Solicitation No.: B240003BAG

Solicitation Name: Sunniland / Nine Mile Run Drainage Improvement Project

Subject: Addendum Number 1

WEIR DESIGN - WEIR-1									
SUNNILAND / NINE MILE RUN DRAINAGE IMPROVEMENT PROJECT									
LEE COUNTY, FLORIDA									
DATE	PROJECT	DRAWING	DESIGN	DRAWN	CHECKED	SCALE	SHEET		
5/14/2019	8234	_WEIR-1	KWK	SDJ	KWK	AS NOTED	17A

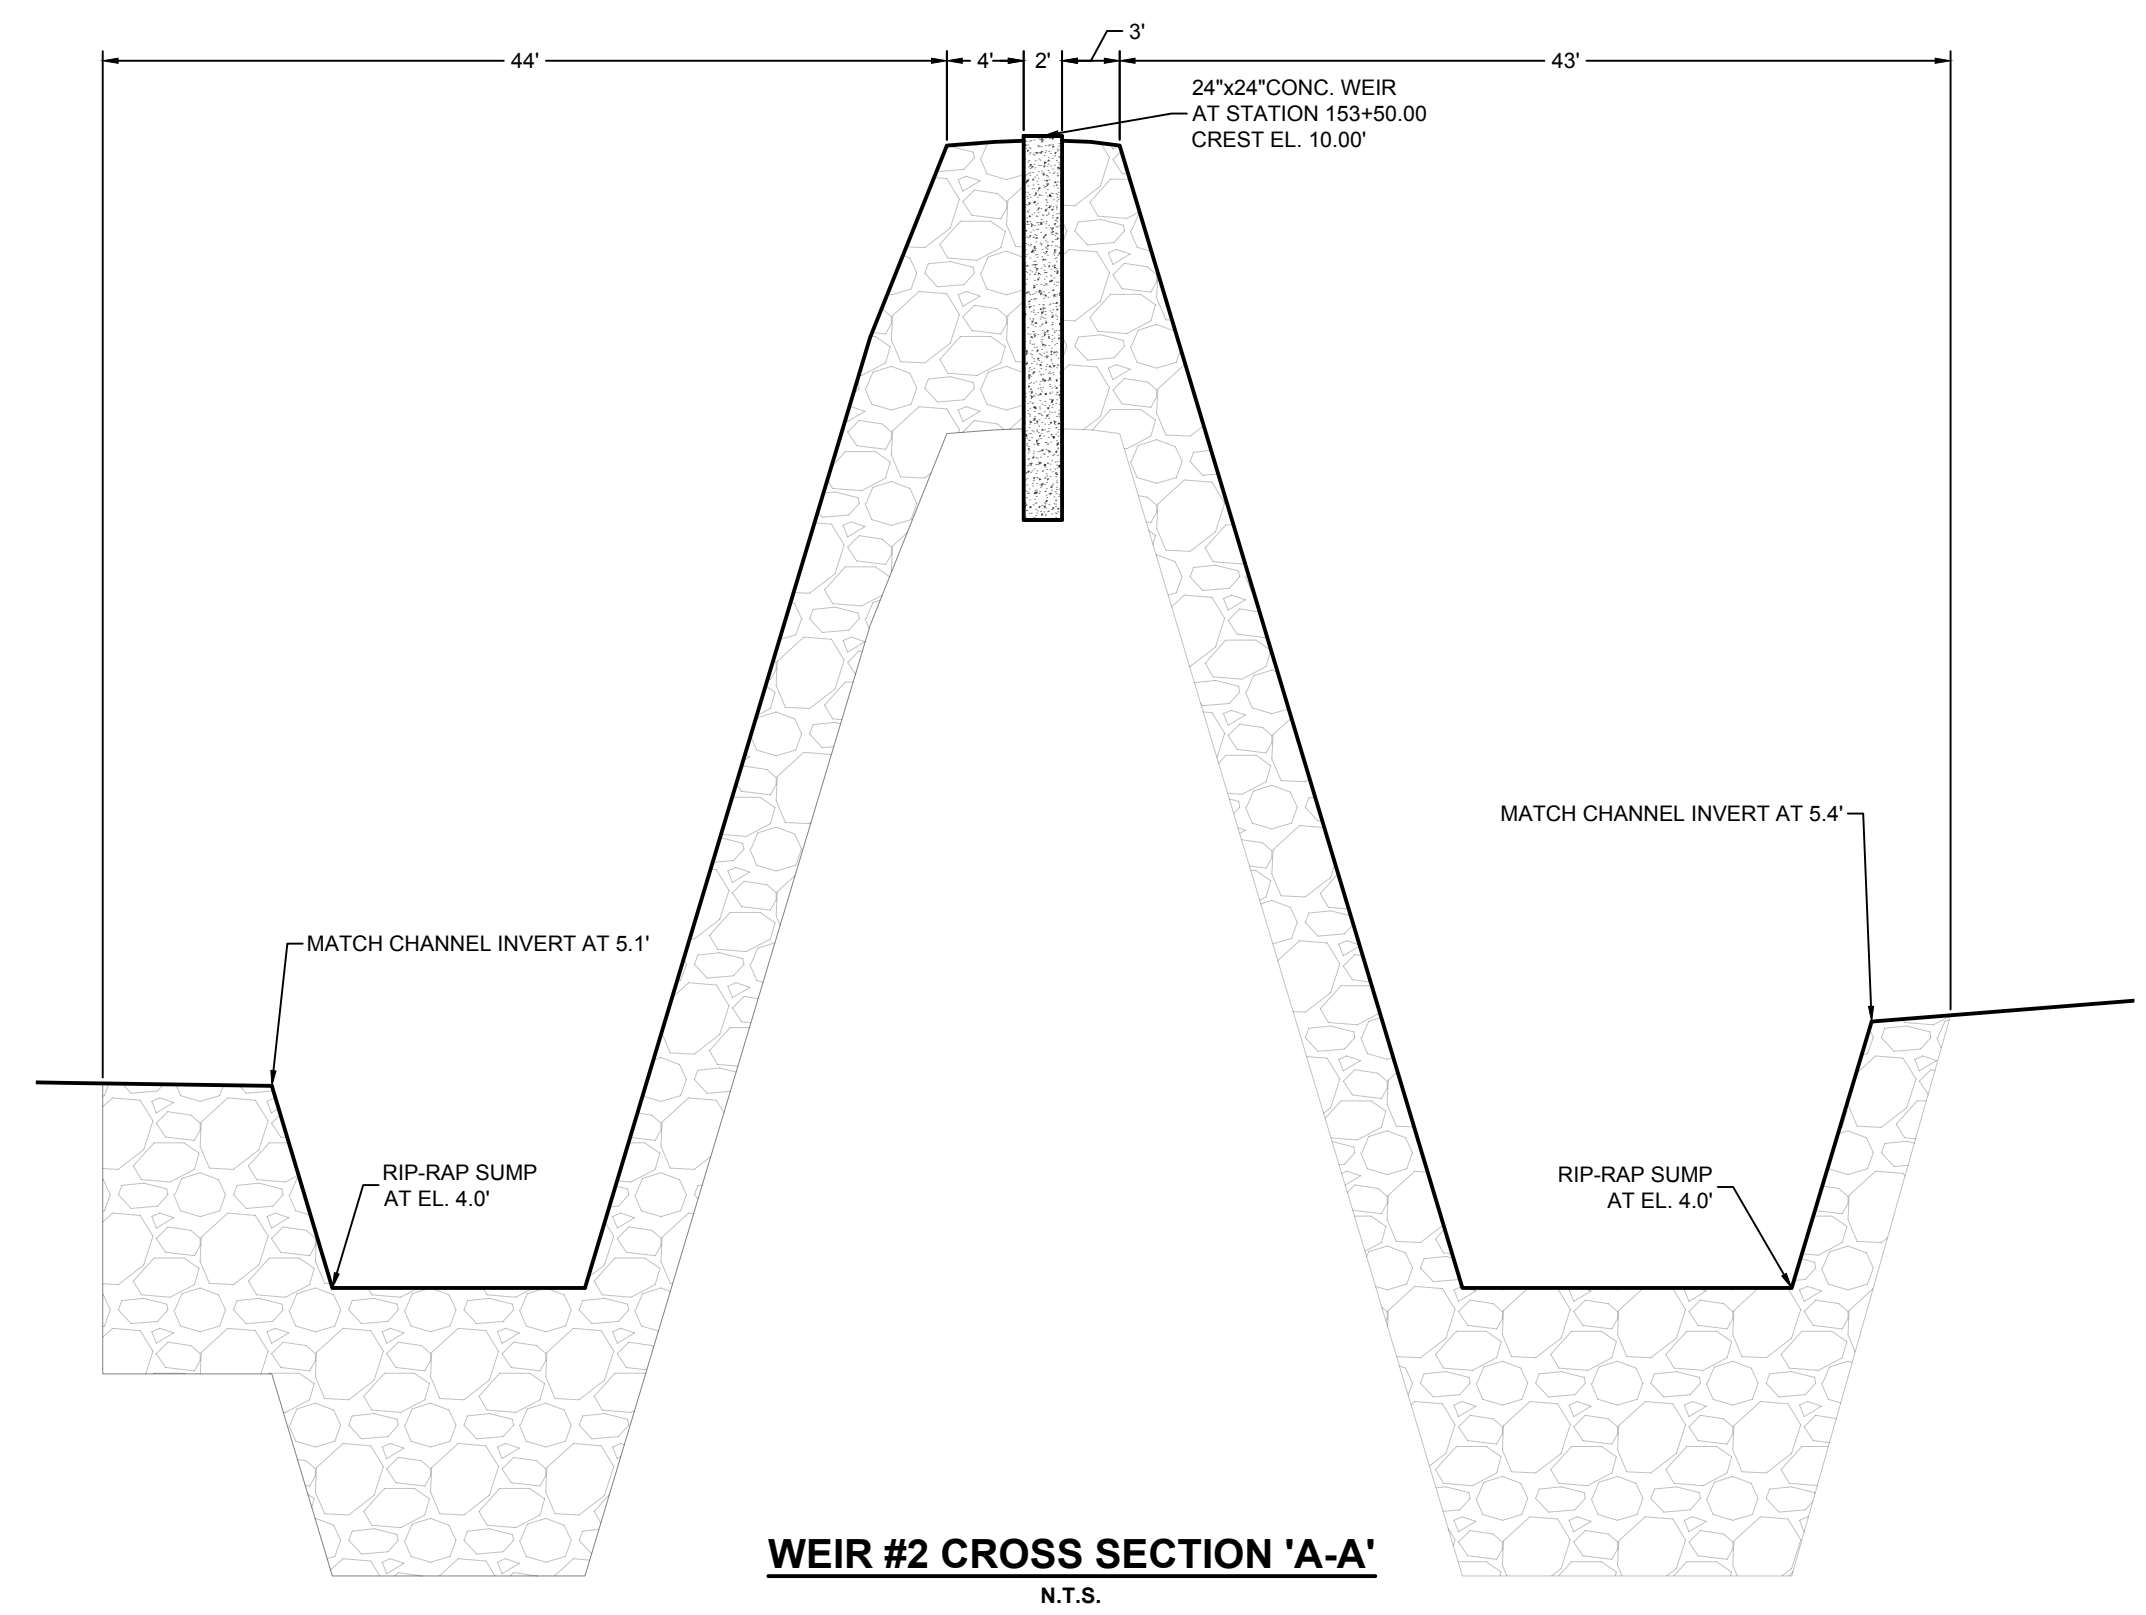
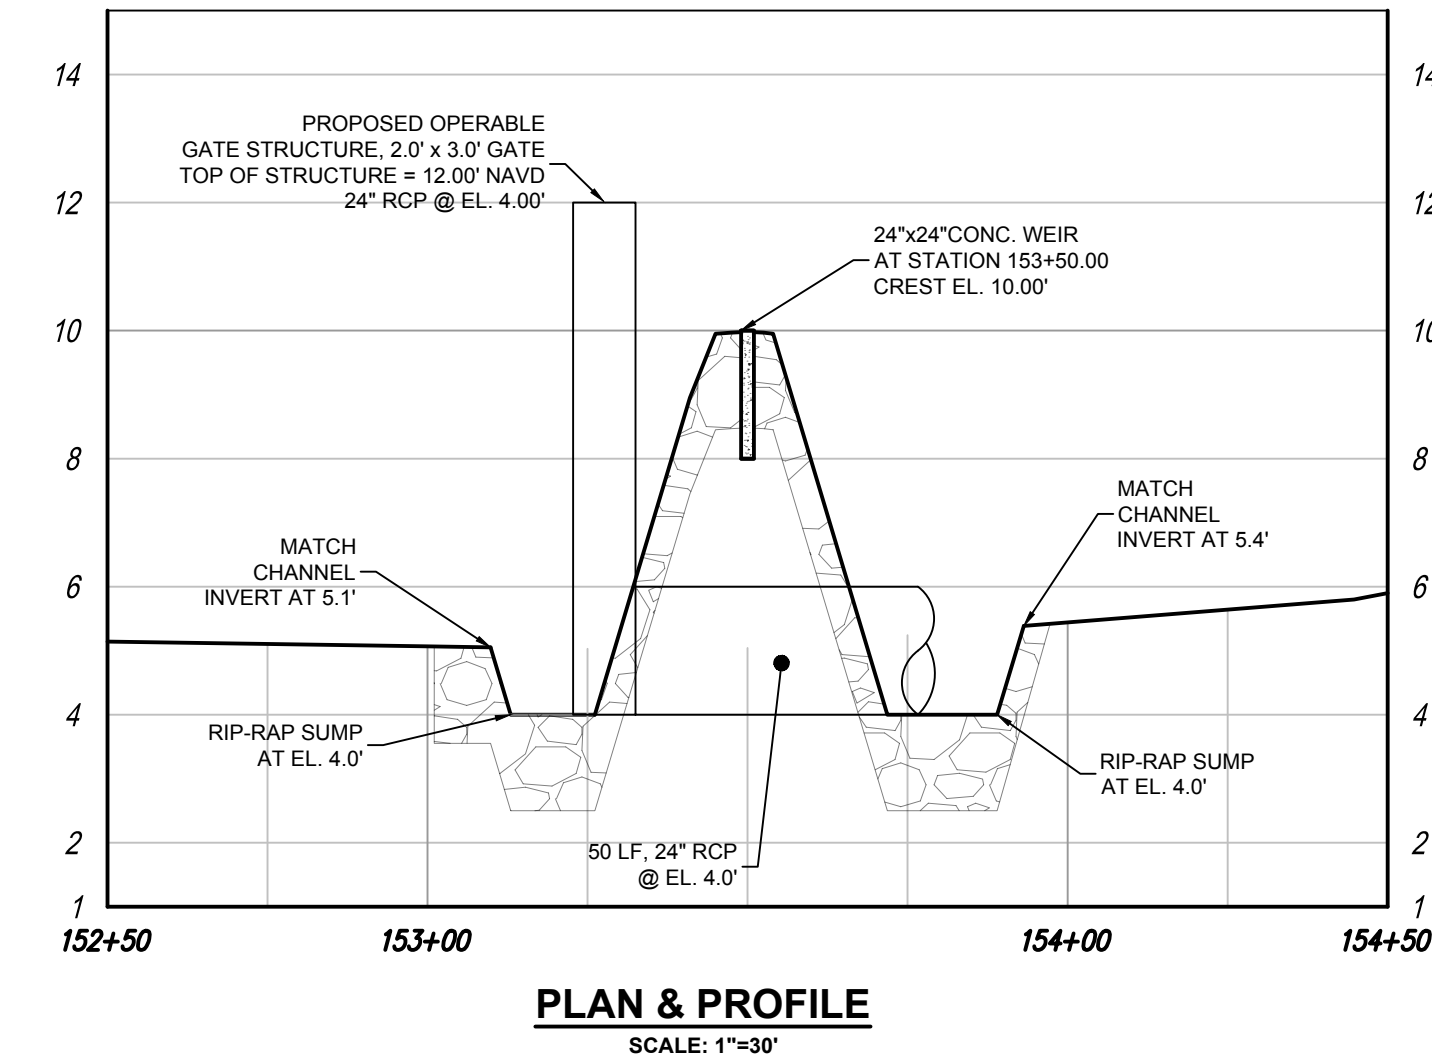
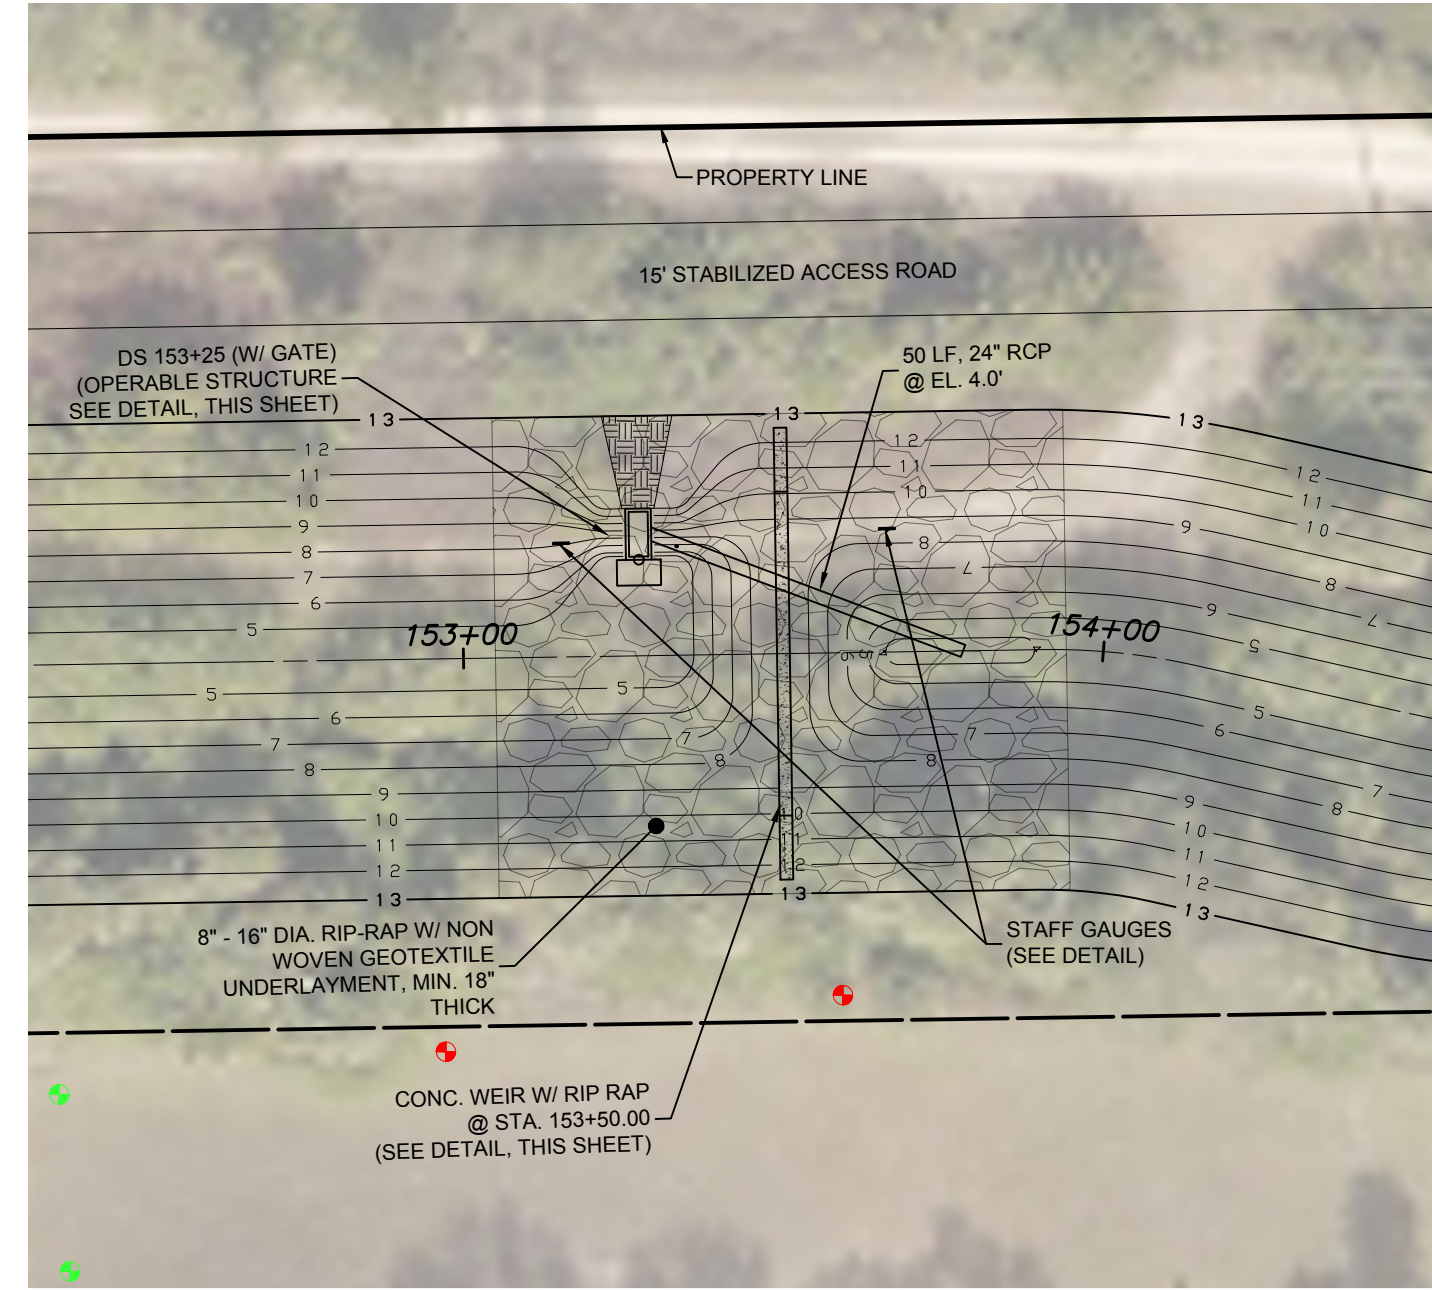
Answer	10-ft down from the top of bank
10.	Regarding weir's # 1 & 2, please clarify the following. Sheet 17 shows a FDOT index 252 that depicts a typical weir section. However, sheets 17A (weir # 1) & 17B (weir # 2) shows a typical weir section which is a concrete 2' x 2' area. Question, which section is correct?

15.	Can the engineer provide some additional clarification for the two through weirs? Sheet 17 depicts a typical section of a type of through weir, sheets 17A and 17B depict a 24" x 24" weir detail, however the X-section A-A shown on both sheets depicts a detail that does not reflect either of the individual weir details. Please advise.

Answer	Sheets 17A and 17B are correct. Disregard FDOT Index 252.
11.	If the work is to be majority if not all self-performed does the contractor still need to run an add for the DBE requirement?

Answer	Sheets 17A and 17B are correct. Ignore section on sheet 17.
16.	Drawing Sheet 5 depicts (3) thirty-inch RCP mitered end sections. However, the bid form does not list any. Can a new 30" MES bid item be included on a revised bid form?
